~~A PORTION OF~~ PARKER AND PINE FILING NO. 1 , Lot 3

SITE PLAN

SLIM CHICKENS

SWC OF S. PARKER ROAD AND E. PINE LANE, PARKER, CO 80134

C1.0

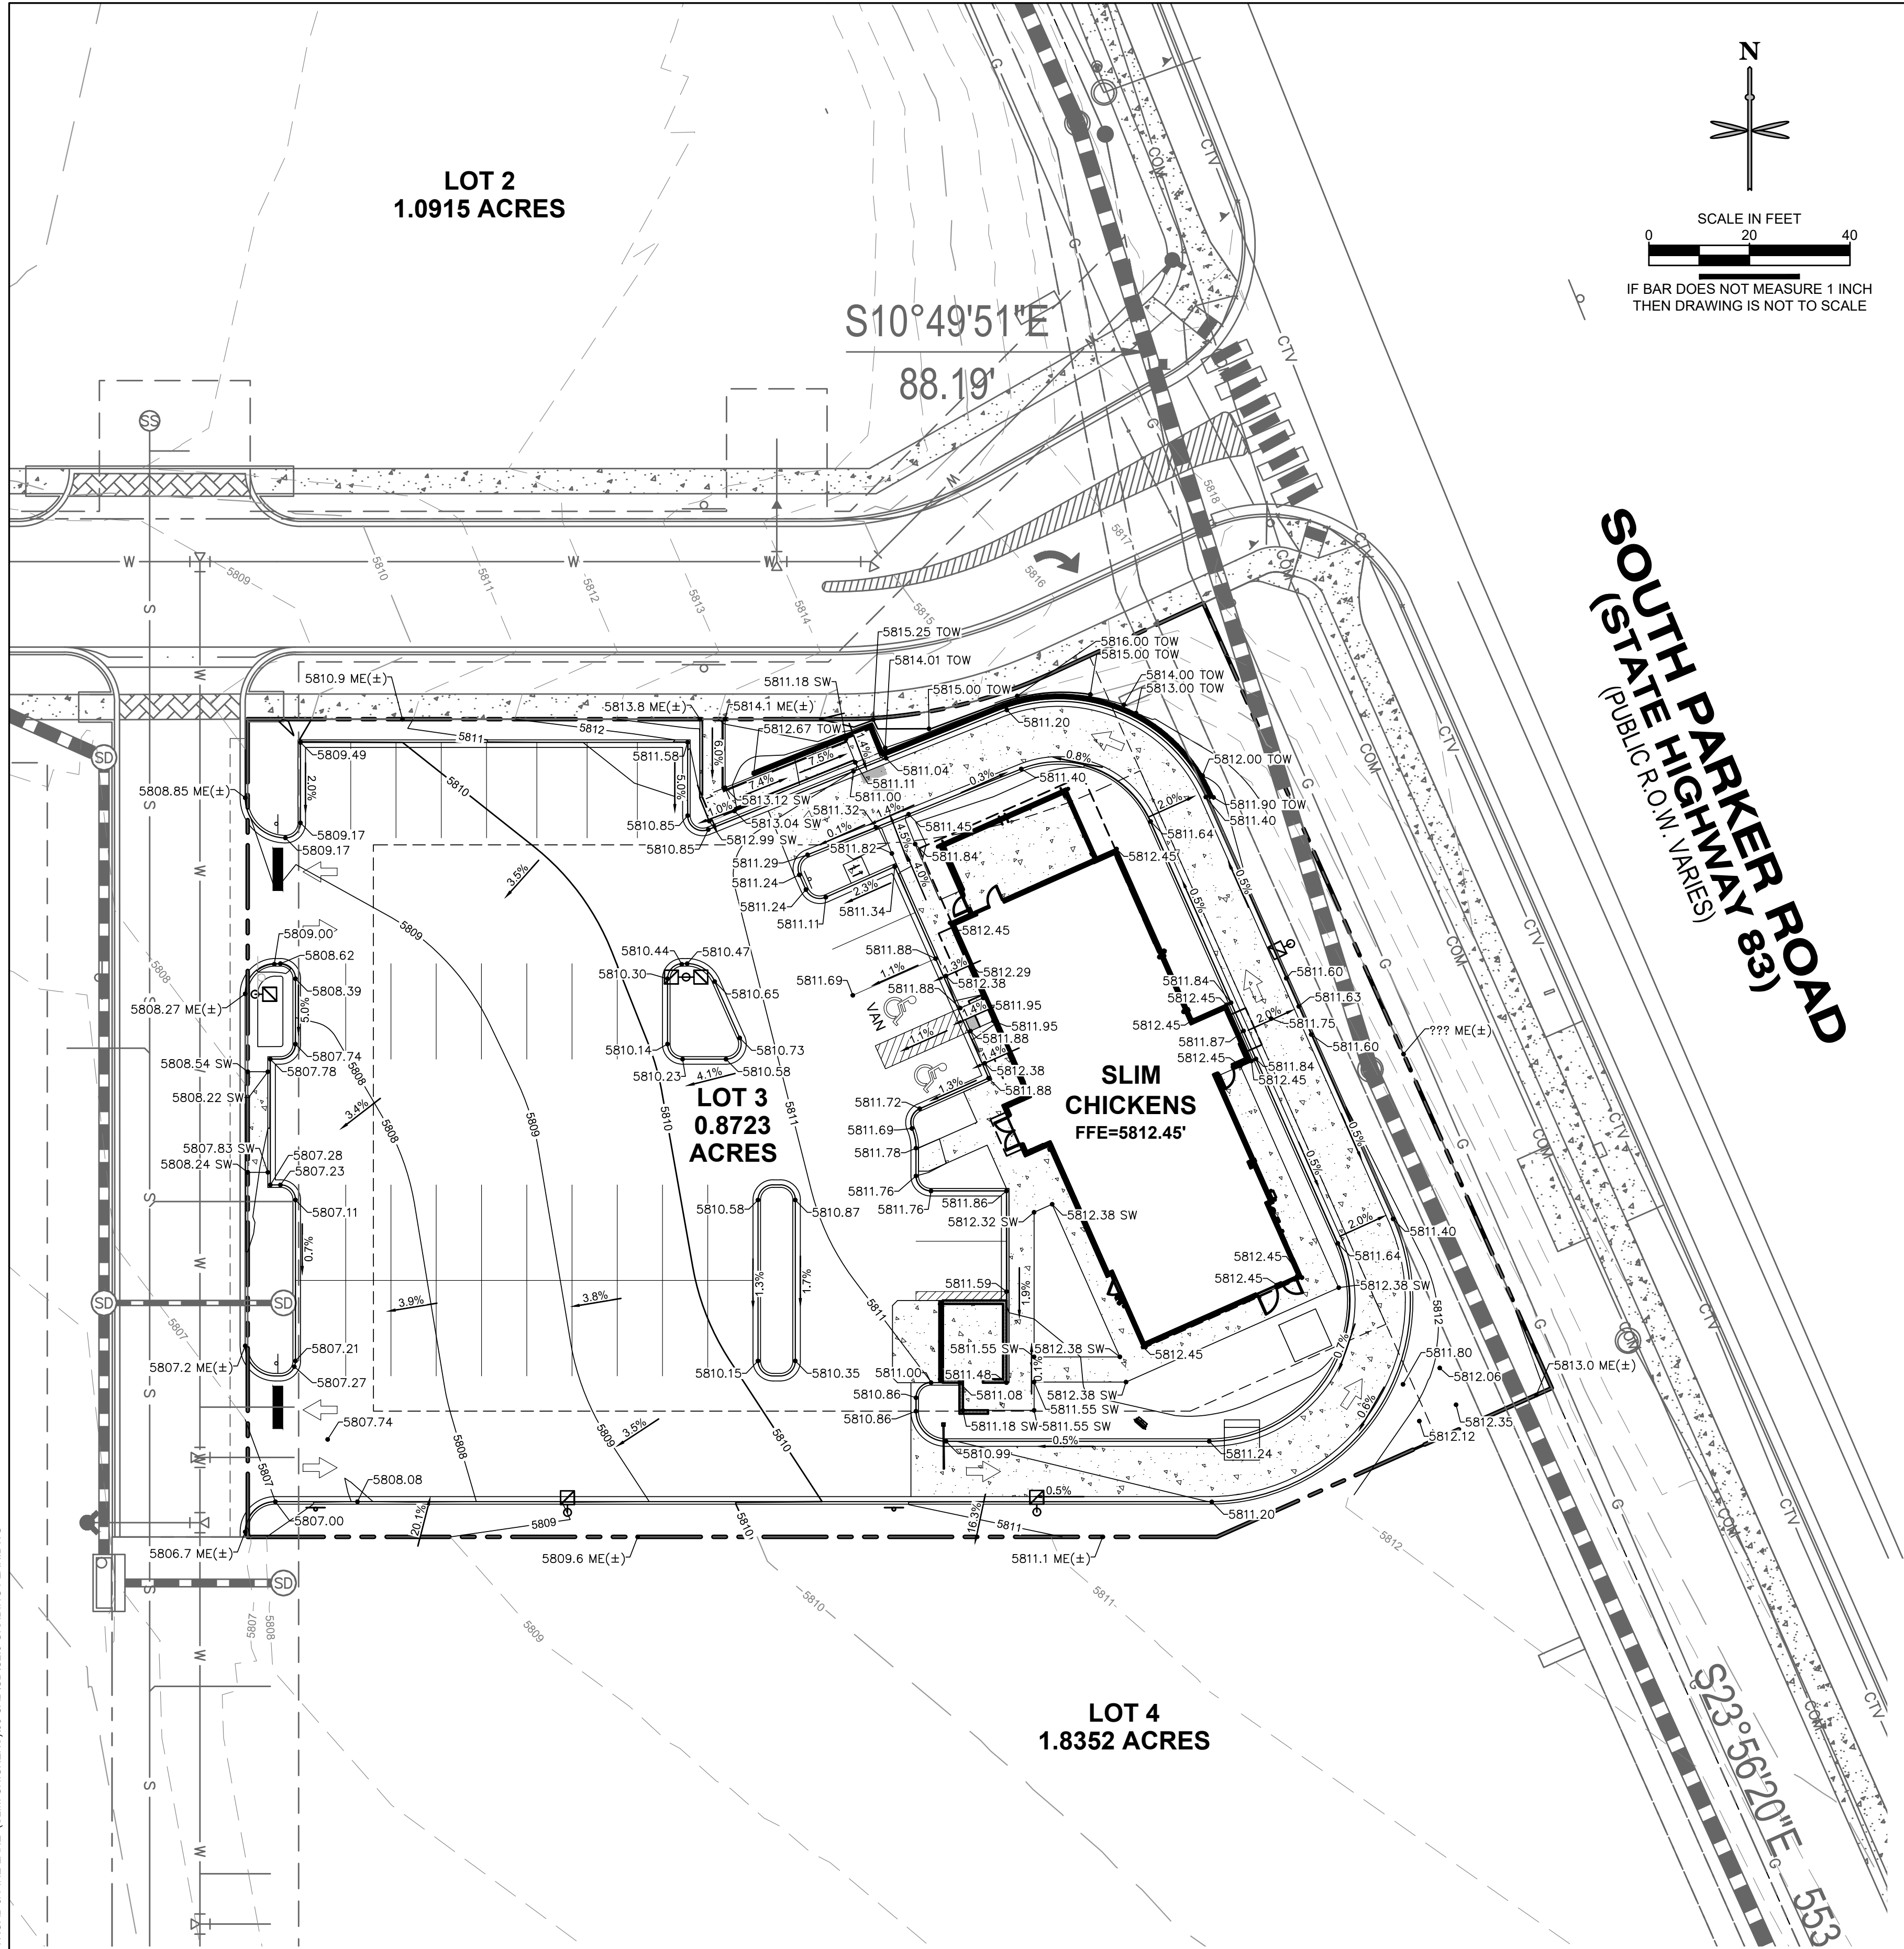
Remove note #2. New 8' sidewalk to be constructed along Parker Road side as a part of this site plan (per previous subdivision process). There is no existing sidewalk internal to existing site. **See further comments regarding the Parker Road sidewalk in the Landscape Plan.**

- 6 EXISTING SANITARY MANHOLE TO REMAIN
- 7 EXISTING FIRE HYDRANT TO REMAIN
- 8 ~~EXISTING~~ CROSSWALK STRIPING Or is this to be a different surface treatment at the crossing?

- 9 ~~EXISTING SIGN TO REMAIN~~ N/A
- 10 EXISTING CURB AND GUTTER TO REMAIN
- 11 BEGIN CURB CUT. MATCH EXISTING CURB AND PROVIDE AN EXPANSION JOINT AT THE INTERFACE WITH EXISTING.

- 19 PROPOSED CONCRETE SIDEWALK Are there separate plans the clearance bar? If so, please provide
- 20 PROPOSED CONCRETE PAVEMENT
- 21 PROPOSED ASPHALT PAVEMENT

P4.1

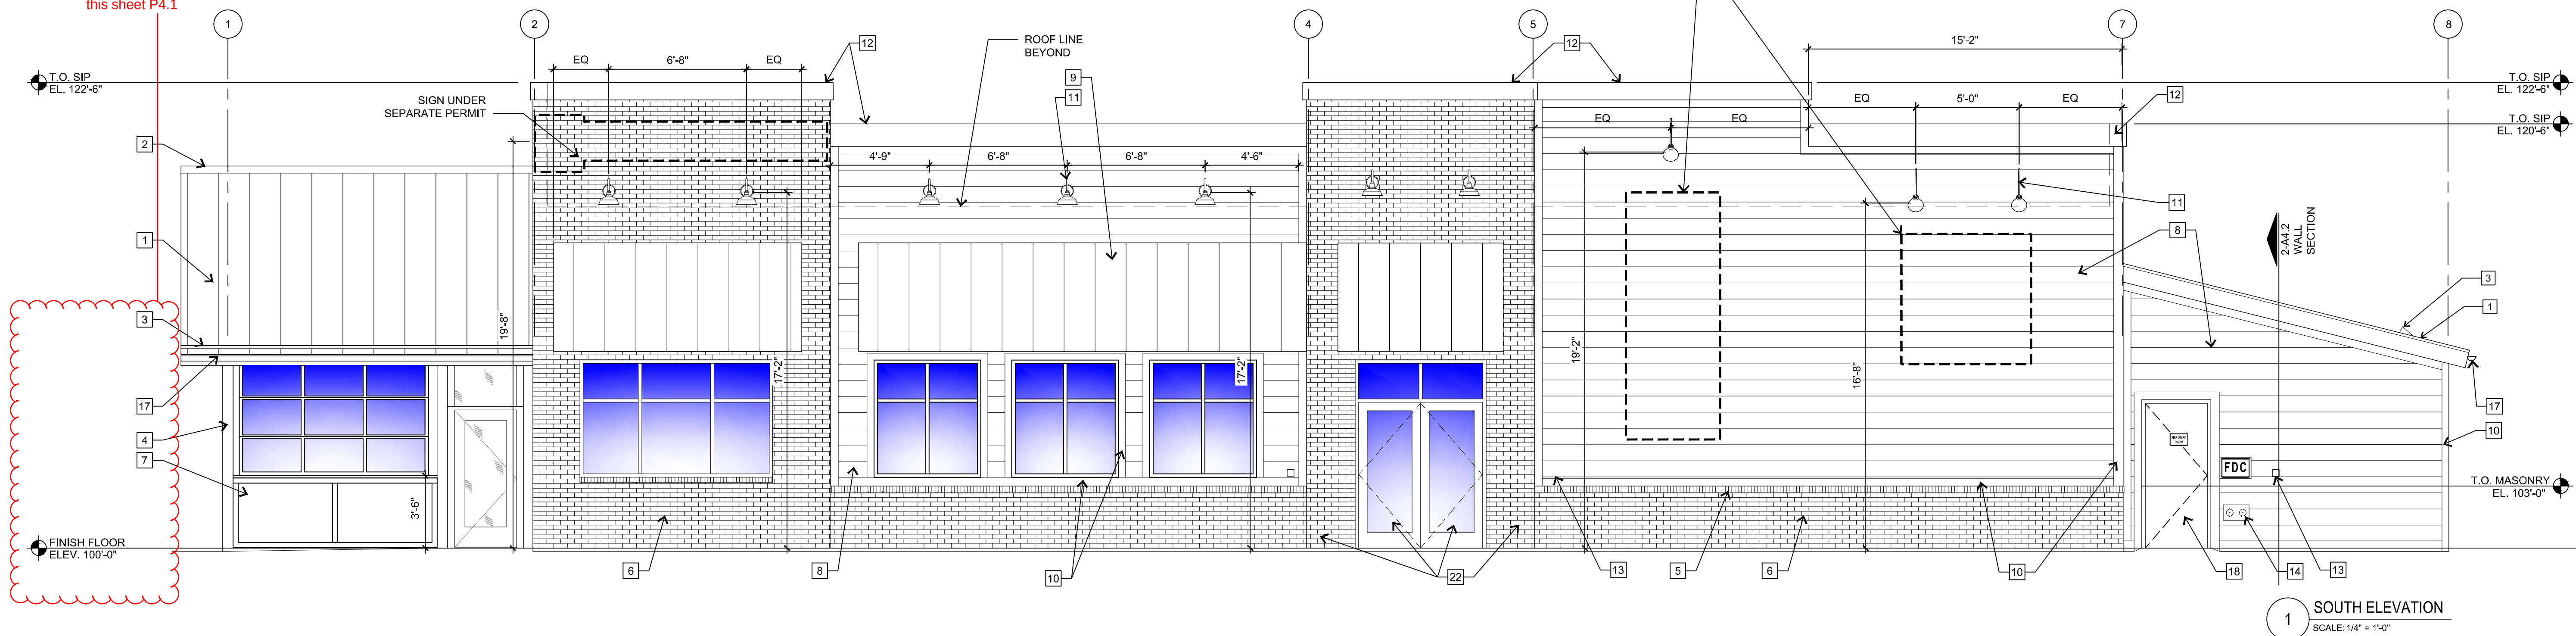
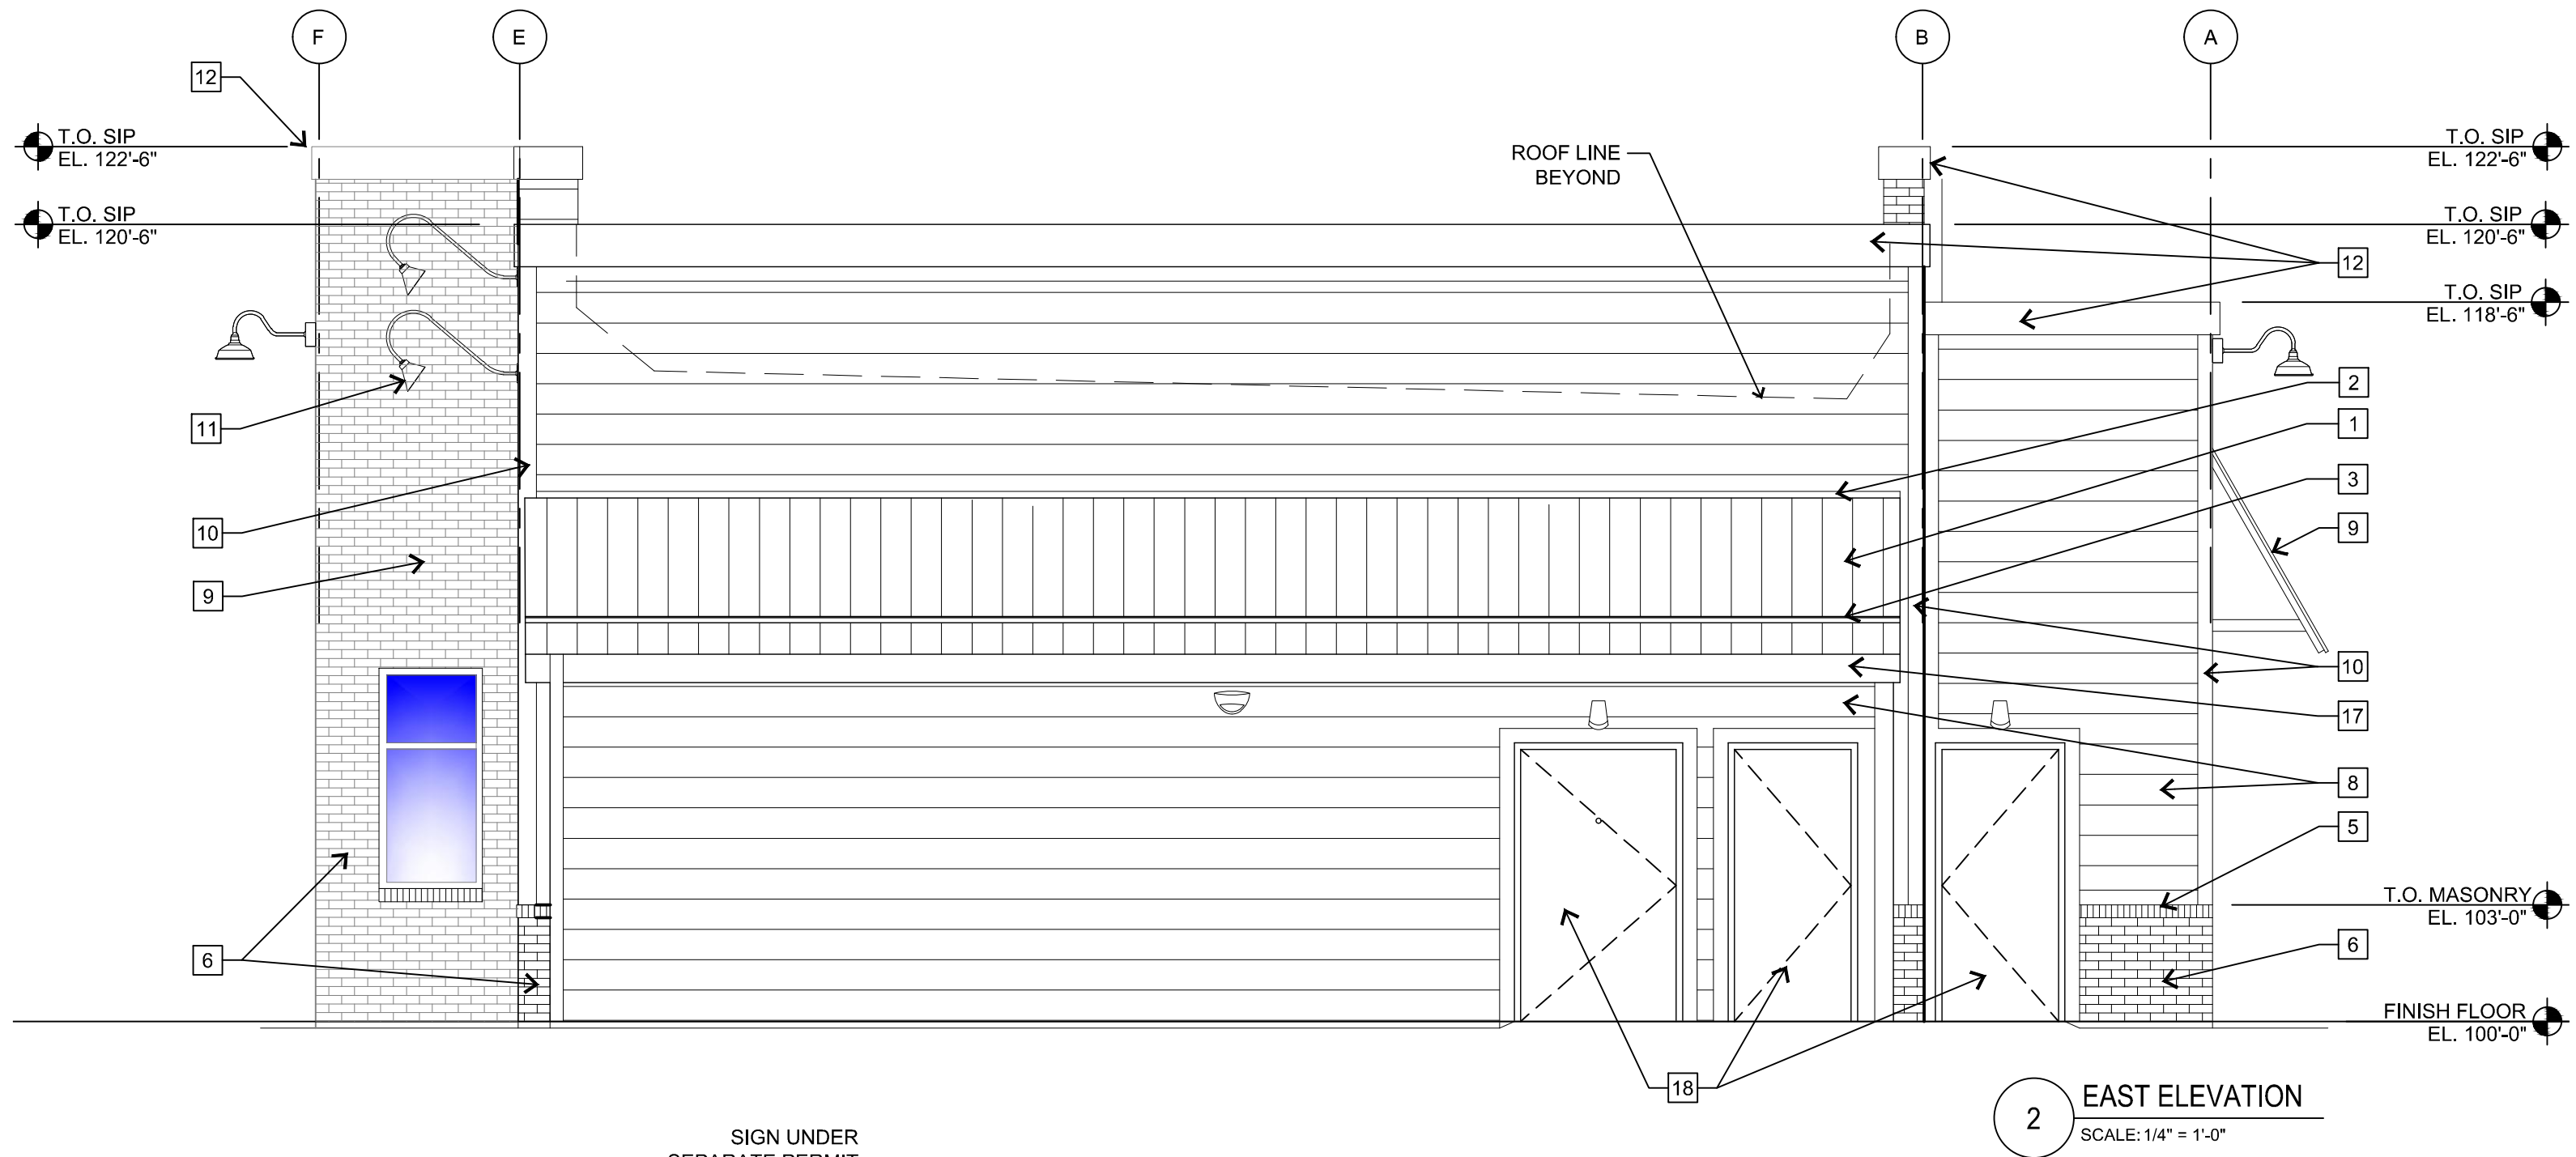
- As noted on colored building elevations, please add all rooftop mechanicals and RTUs to site plan & elevations. Include dimensions.

As noted on colored building elevations, please add fenced patio to either P4.0 or this sheet P4.1
